Request For Information - 161

The Cora Apartments (19 W Harrison)

Subject:	**Acoustical Revisions in L/W Units**	**Status:**	**Open**
Drawing #:		**Spec Sect #:**	
Addendum:		**Submittal #:**

Exxel SKS-01:
Level 1 NW
Corner Floor Plan

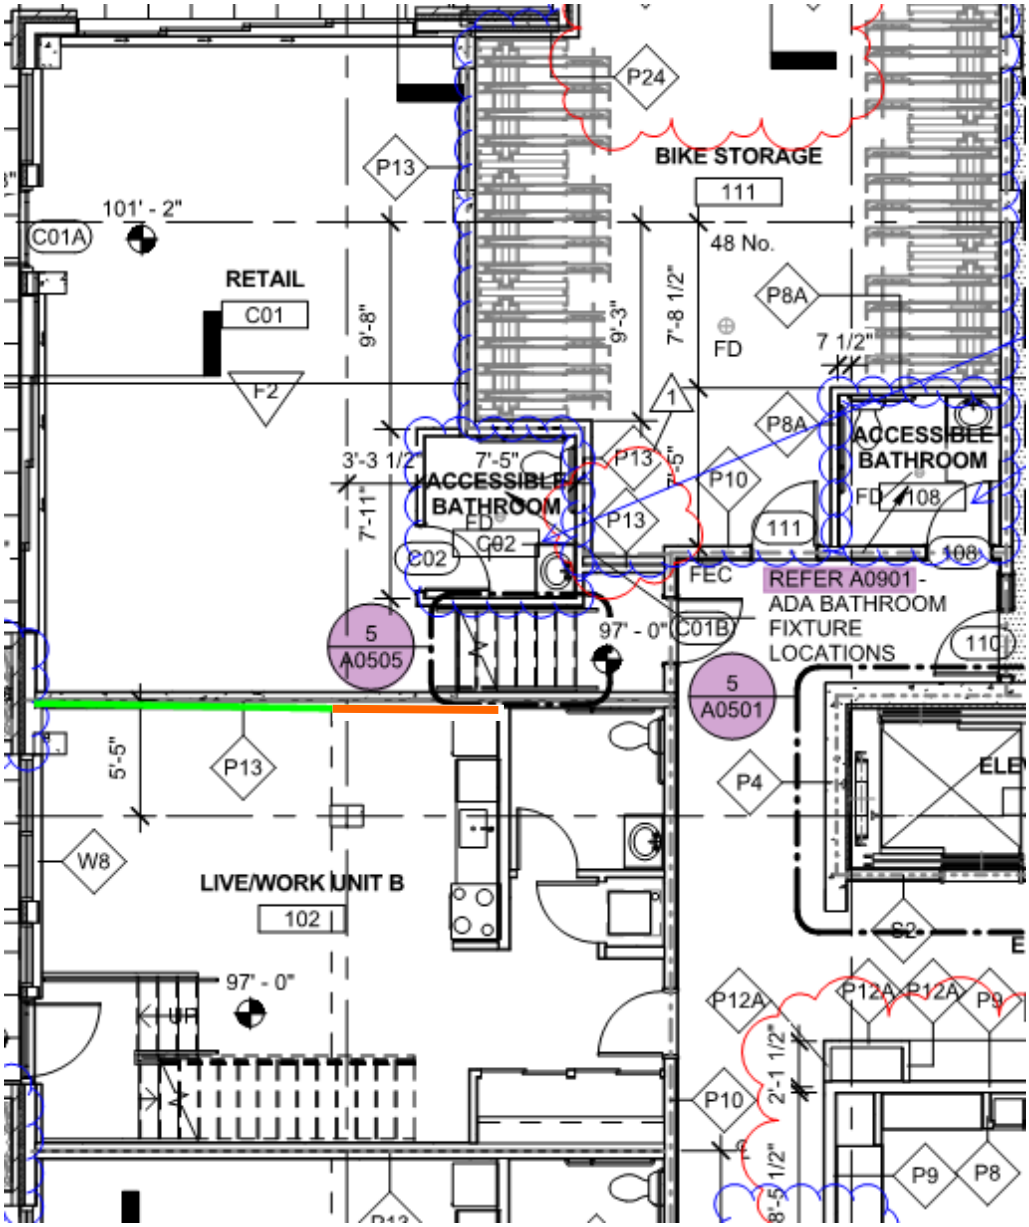
Per the OAC on 6/6/17, it was asked that Exxel provide acoustical revisions in Units 102 & 203, bordering the retail space C01. Please find the attached Exxel SKS-01 & SKS-02 to identify locations for revisions.

Please confirm locations for acoustical revisions and provide details/specifics for the acoustical dampening assembly.

Full Height (Spanning 1 Level) Acoustical Dampening Assembly

Full Height (Spanning 2 Levels) Acoustical Dampening Assembly

Date	Response
6-6-2017	The Owner has elected to add an additional layer of 5/8" GWB over 1/2" Resilient Channel @ 24" O.C. horizontally for the walls shown in Exxel's SKS-01 and SKS-02. JXW

Exxel SKS-02:
Level 2 NW
Corner Floor Plan

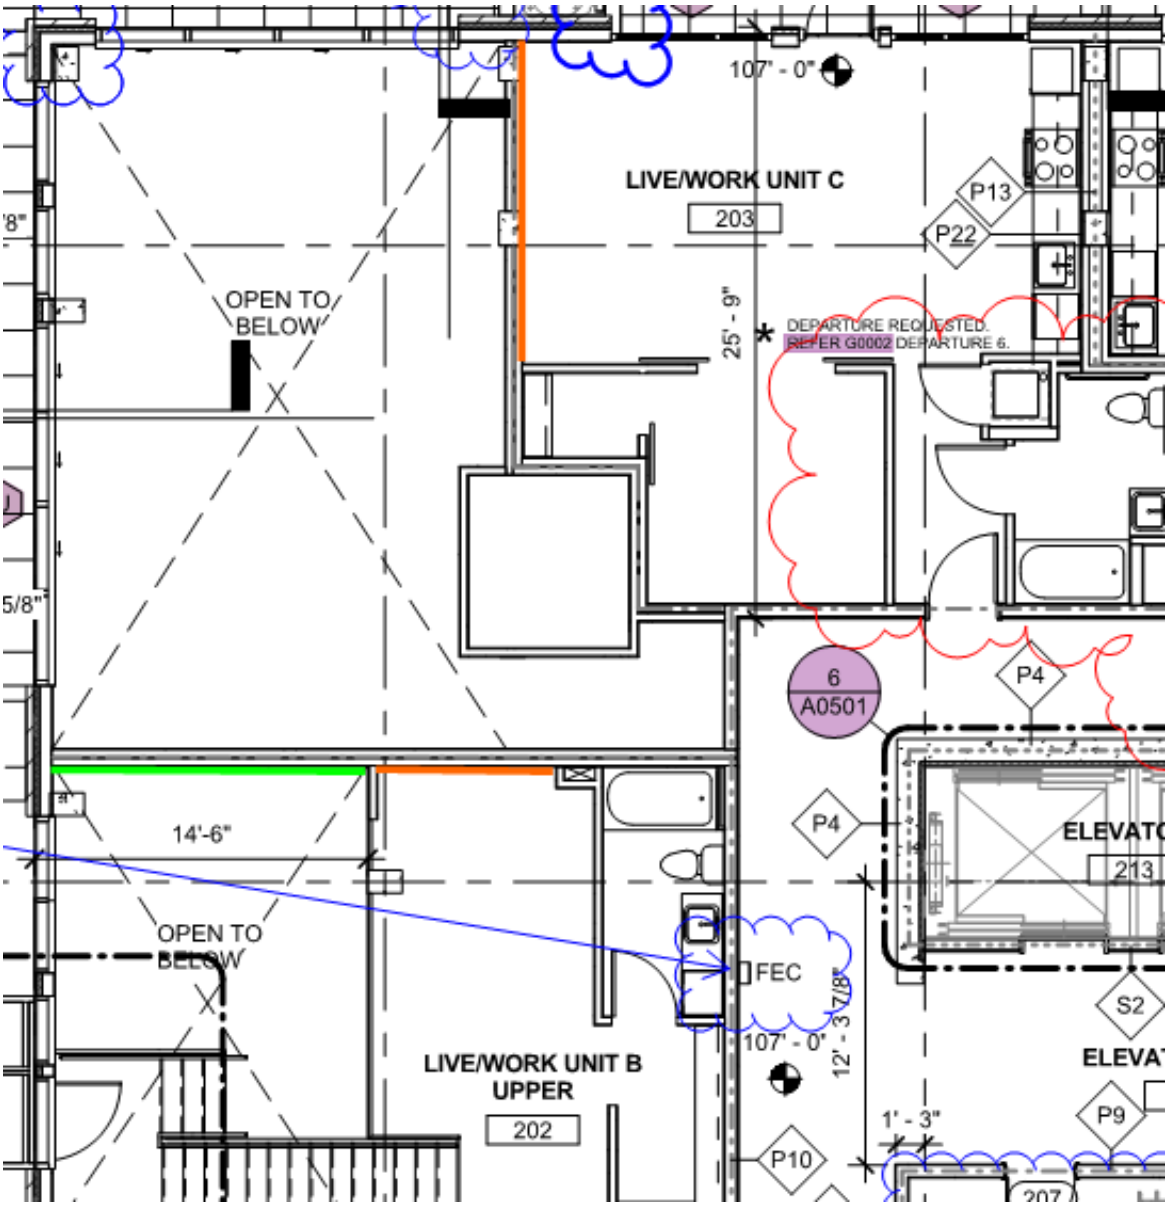
Full Height (Spanning 1 Level) Acoustical Dampening Assembly

Full Height (Spanning 2 Levels) Acoustical Dampening Assembly, continuing from Level 1.
